**Project #19-035  
Mill Creek  
Located at 100 W 100 S**

*Project Name:* Mill Creek  
*Proponent / Owner:* Jared Neilson / Mill Creek of Logan, LLC  
*Project Address:* 100 W 100 S  
*Request:* Design Review Permit  
*Current Zoning:* Town Center 1 (TC-1)  
*Type of Action:* Quasi-Judicial  
*Date of Hearing:* September 12, 2019  
*Submitted By:* Aaron Smith, Planner II

Staff recommends that the Planning Commission **conditionally approve** a Design Review Permit for Project #19-035, Mill Creek, for the properties located at 100 W 100 S, TIN# 02-046-0015,-0016.

LANDSCAPE PLAN

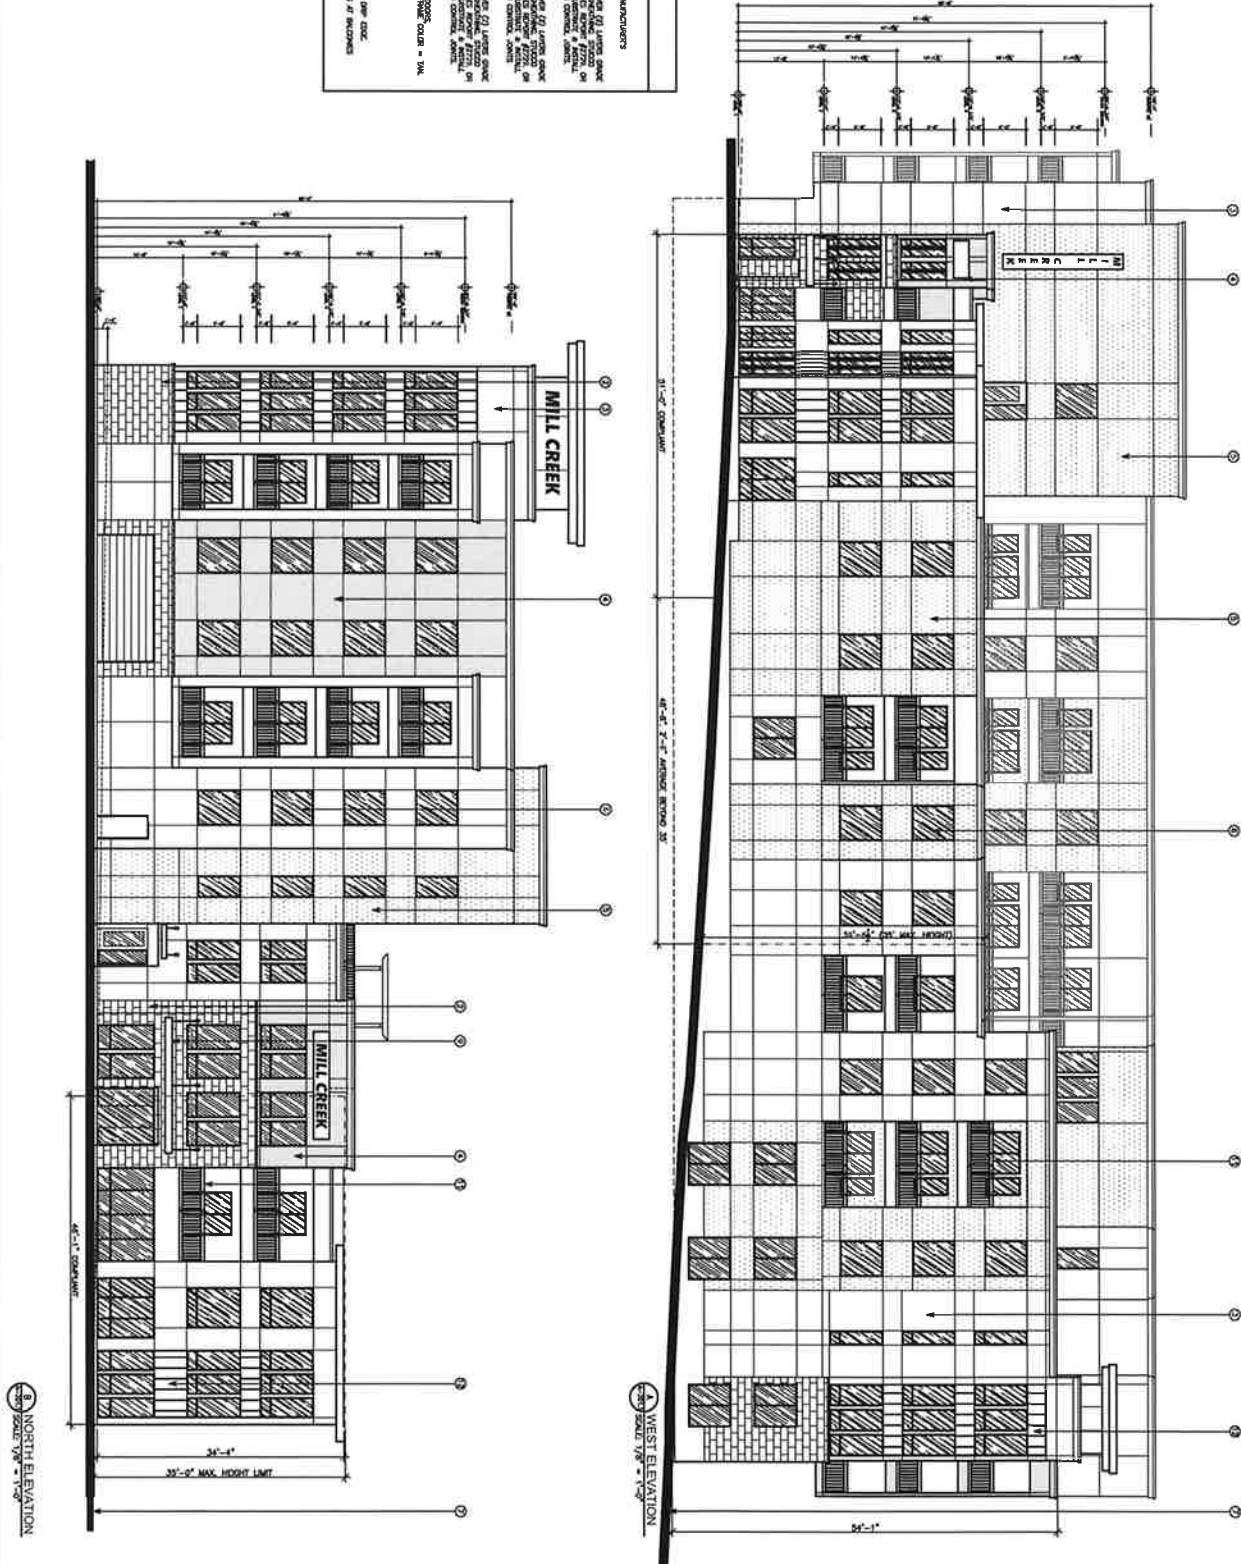
The LDC 17.32 requires minimum plant material for overall visual aesthetics, ecology, screening, and shading purposes. The LDC requires a minimum of 20 trees and a combination of 50 shrubs, flowers and ornamental grasses per acre of land in the COM zone. For the .94 acre project site, 19 trees and 47 shrubs, flowers and ornamental plants are required. The proposed landscaping plan includes landscaped areas around the building, parking lot, and roof top patio. In total 54 trees and 305 shrubs, flowers and ornamental plants are proposed. The design of the planting areas along both the 100 S and 100 W frontages, including columnar trees, will help to break up and buffer the ground level building facades and parking areas. Additional project landscaping includes a 6,661 SF turf area, and a 1,545 SF artificial turf area

that will serve as a dog park for residents. As conditioned, with a performance landscaping plan, the project meets the requirements in the LDC.

12. Double loaded parking stalls shall be assigned to the same dwelling unit.
13. A performance landscaping plan, prepared in accordance with §17.39 of the LDC and consistent with the proposed landscaping, shall be submitted for approval to the Community Development Department prior to the issuance of the building permit.

14. Street trees shall be planted along all adjacent streets at 30 feet on center.
15. Enhanced vertical landscaping that matches "Type C" in LDC 17.32.070 shall be placed in the areas between the sidewalk and the parking lot along 100 West.

EXTERIOR ELEVATIONS

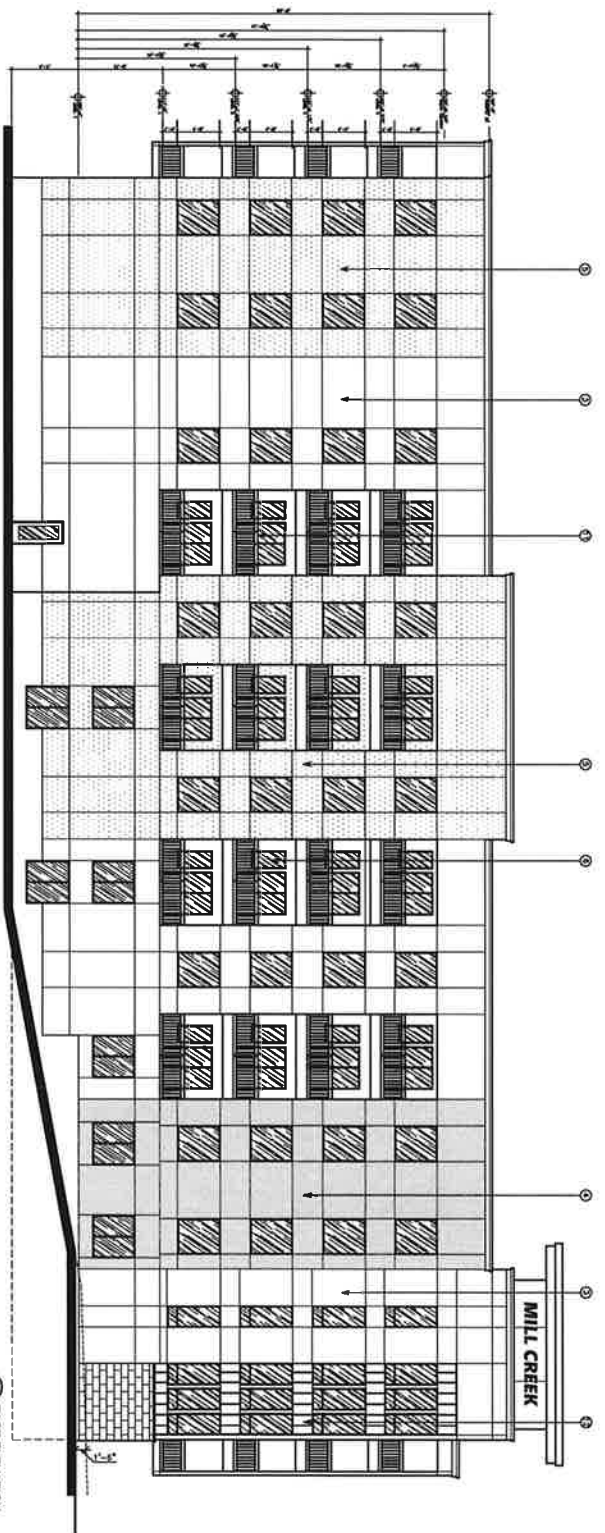
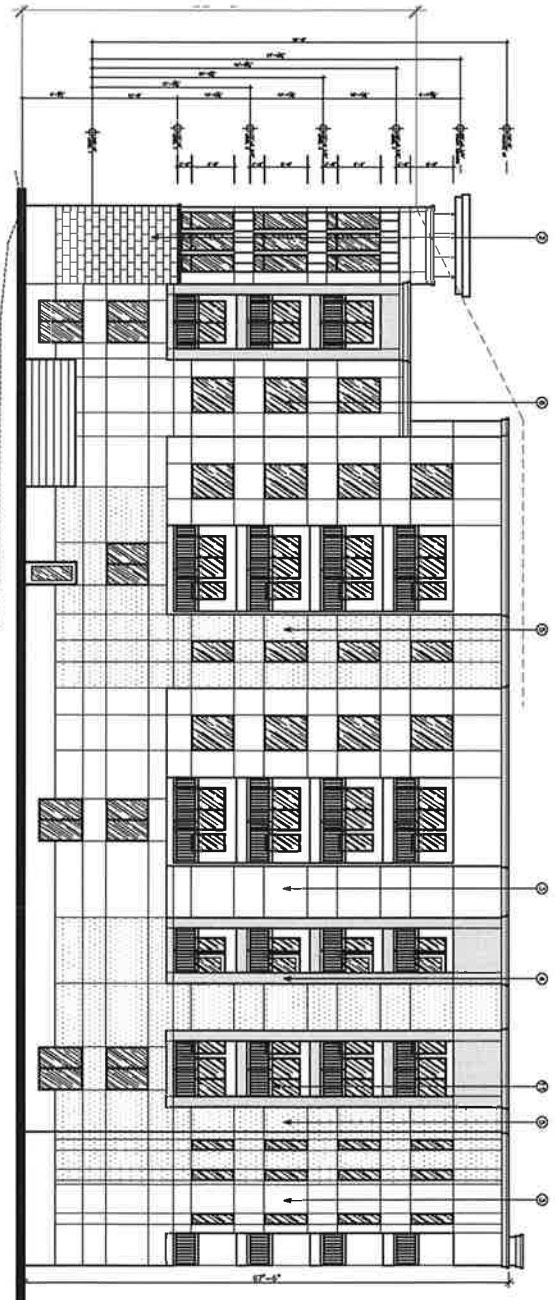
Floors 4-6 (non-concrete floors all sides):	35%-40%
North Elevation (100 S Frontage):	28%
West Elevation (Ground Floor/Parking Lvl 2):	17%
West Elevation (Parking Lvl 1):	23%
South Elevation (Parking Lvl 1):	10%
South Elevation (Parking Lvl 2):	10%
East Elevation (Parking Lvl 1):	10%
East Elevation (Parking Lvl 2):	7%

The transparency on the inhabited floors are all compliant with the LDC. Many of the ground floor areas that are primarily structured parking are not compliant with the code. The transparency code in the LDC generally specifies street facing or exposed sides as being of particular importance for meeting transparency requirements. As the TC-1 Residential Transparency requirement does not make a specification regarding exposed sides, the code has been interpreted by staff as applying to all sides of the building. It is within the Planning Commission's purview to broadly or narrowly apply the transparency requirement to apply to all sides or only the exposed sides, which would include the 100 S and 100 W street facing facades. As transparency is considered a design element of the building, the Planning Commission may reduce the requirement below 20%. As conditioned, with the planning commission requiring the 20% transparency requirement only on exposed sides, the project meets the requirements in the LDC.

The LDC requires 4-sided architecture that emphasizes similar architectural features on all sides of the building. The buildings primary entrance and architectural emphasis is on the 100 S frontage. Repetition of materials, fenestration, and architectural details are repeated on the various facades. One area that lacks consideration is the southern portion of the east façade, both the parking lvl1 and lvl2 floors. This area includes a 48' and 71' blank wall. Blank areas of wall that are visible from a public right-of-way that exceed 40' are prohibited. Vertical detailing, including window/door breaks, changes in wall planes, change in texture/color/materials, or use of vertical elements, including vertical plantings, may be used to break up the façade in this

area. As conditioned, with either additional architectural features or landscape and screening to buffer the areas of the eastern wall, the project meets the requirements in the LDC.

17. All floors along street facing facades shall have a minimum transparency of 20%.
18. The east façade (parking structure section) that is visible from the street and has blank wall sections of 40 feet or more shall either have additional architectural features or landscaping buffers planted to screen views.
